TO: Mercedes-Benz Dealer Principals, General Managers, Sales Managers, Service Managers, Parts Managers	FROM: Gregory Gunther, Department Manager, Vehicle Compliance and Analysis, Engineering Services
RE: Recall Campaign Launch Notification Check Pano Roof Bonding, Rework if Necessary MY18-19 X156 (GLA-Class)	DATE: April 5, 2019

Campaign No. 2019030006, March 2019

SUBJECT: **Model GLA-Class vehicles (156 platform)**
Model Year 2018-2019
Check panoramic roof for leak tightness and rework, if necessary

Figure 1

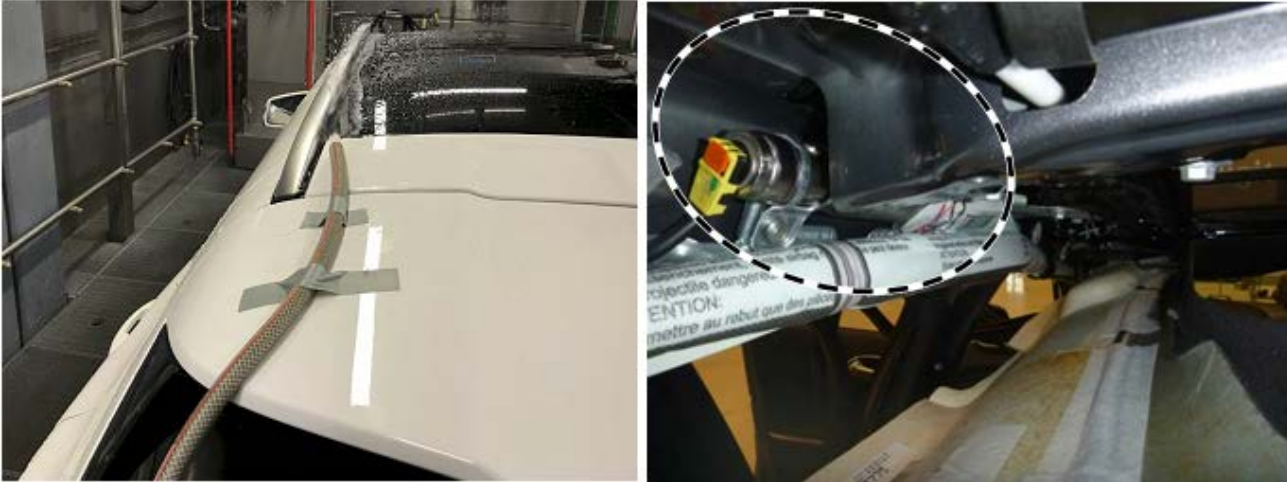
2. Perform leak test (**rain test**) (**figure 1**).

i Apply water (**at least 10 l/min**) to panoramic glass roof all-round.

Figure 3

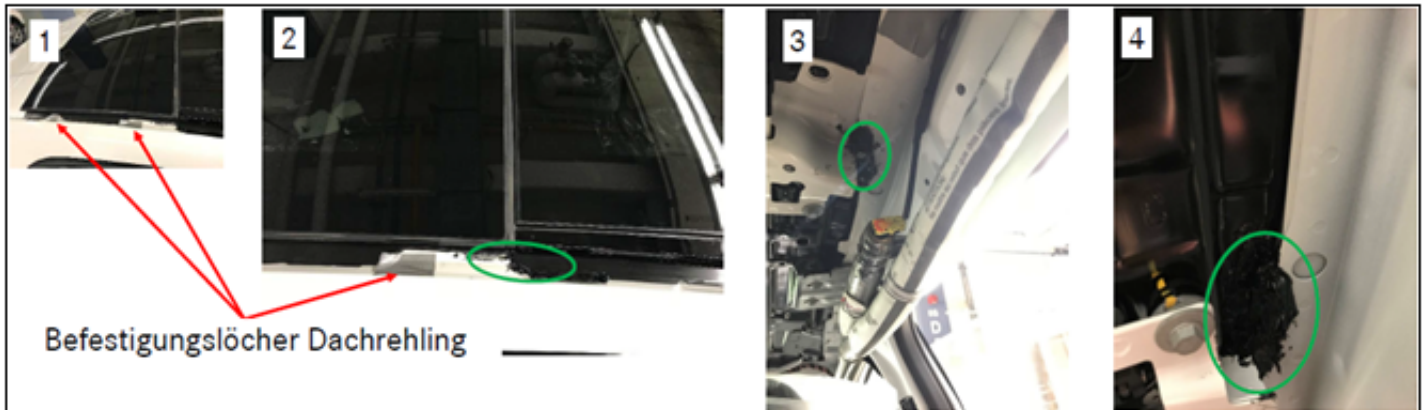
1. Remove drip rail (**AR88.80-P-4000NKB**).
2. Remove roof railing (**AR77.40-P-5000NKX**).
3. Mask off roof railing mounting holes.
4. Perform leak test (**rain test**) again in order to exactly localize the leaky area.
5. Seal localized, leaky area/areas with adhesive from repair adhesive kit (**A 000 989 49 05**) on outside and inside.
